CERTIFICATE OF APPROPRIATENESS

ITEM A06
HPO File #: HP2026_0239

3963 Del Monte Dr
LM: Baldwin-Riddell Houston

Proposal: Alteration – Addition

ROOF PLAN EXISTING

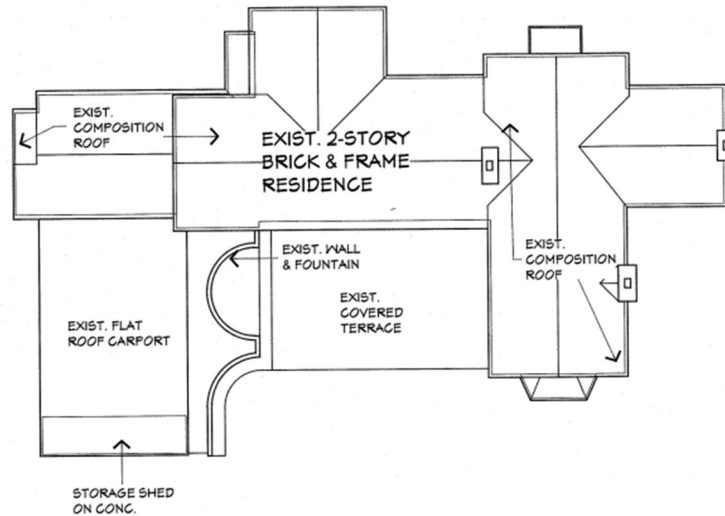
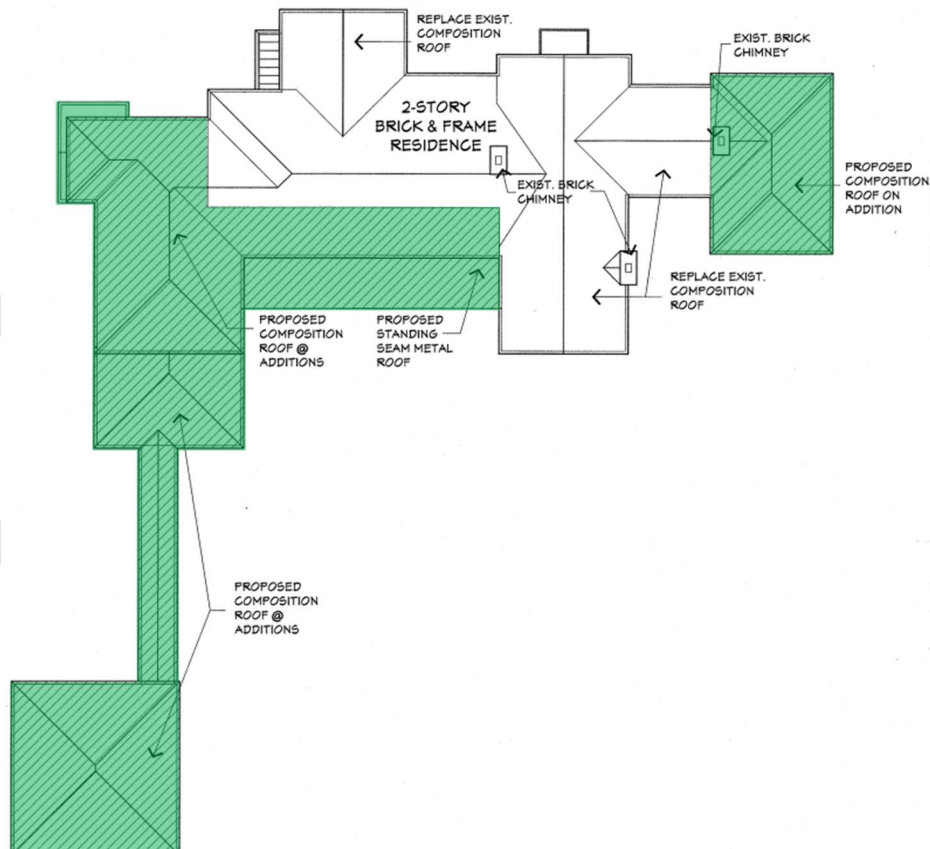
Recommendation: Approval with conditions that the existing ridge height remain at the existing height.

<i>By changing the existing ridge height, the distinguishing qualities and character of the building are slightly altered.</i> |

<i>The proposed alteration does destroy historical material by modifying the height of the roof ridge of the existing structure.</i> |
